HEWLETT-PACKARD

FROM: Greg Shue
TO: NCITS T10
DATE: May 8, 1998
RE: Reconnect time-out

The text of these proposals follows; it references SBP-2 Revision 3d.

Figure 16 – Login ORB

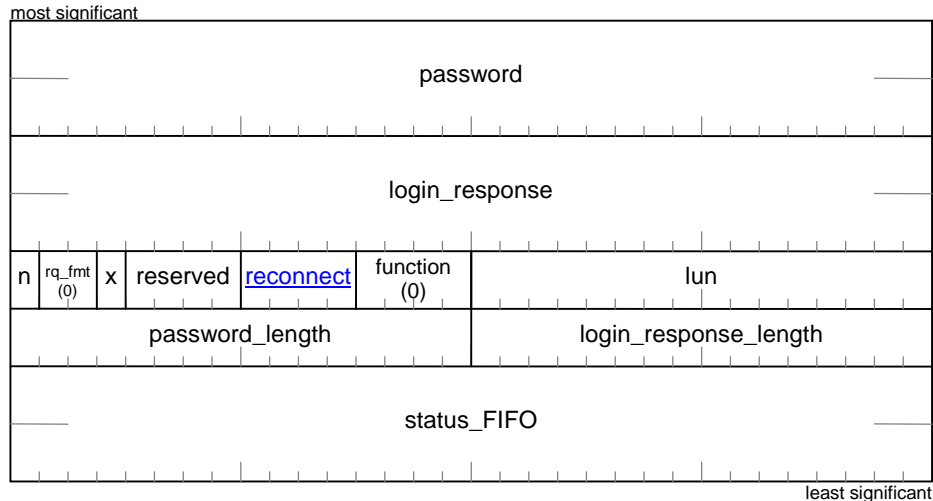
[The *reconnect* field shall specify the desired reconnect time-out as \$2^{\text{reconnect}}\$ seconds. The default reconnect time-out, when *reconnect* is zero, is one second. The target may not be able to support the requested value; see *reconnect_hold* in the login response data below.](#)

Figure 17 – Login response

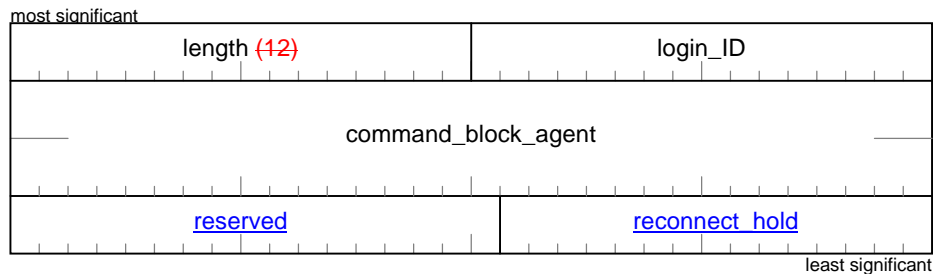
If the login fails the contents of the response buffer are unspecified. Otherwise, upon successful completion of a login, the response is returned in the format illustrated below target shall store a minimum of 12 bytes of login response data and may store up to the entire 16 bytes illustrated below so long as the amount of data stored is an integral number of quadlets. Truncated login response data shall be interpreted as if the omitted fields had been stored as zeros.

The *length* field shall contain the length, in bytes, of the login response data ~~and shall be equal to 12.~~

The *reconnect_hold* field shall specify the time, in seconds less one, that the target will hold resources for a previously logged-in initiator subsequent to a bus reset. The value of *reconnect_hold* shall not be greater than $2^{\text{reconnect}} - 1$, where *reconnect* is obtained from the login request. If an initiator fails to complete a successful reconnect request within *reconnect_hold* + 1 seconds after a bus reset, the target will perform a logout and release all resources held by that initiator (see 8.3).
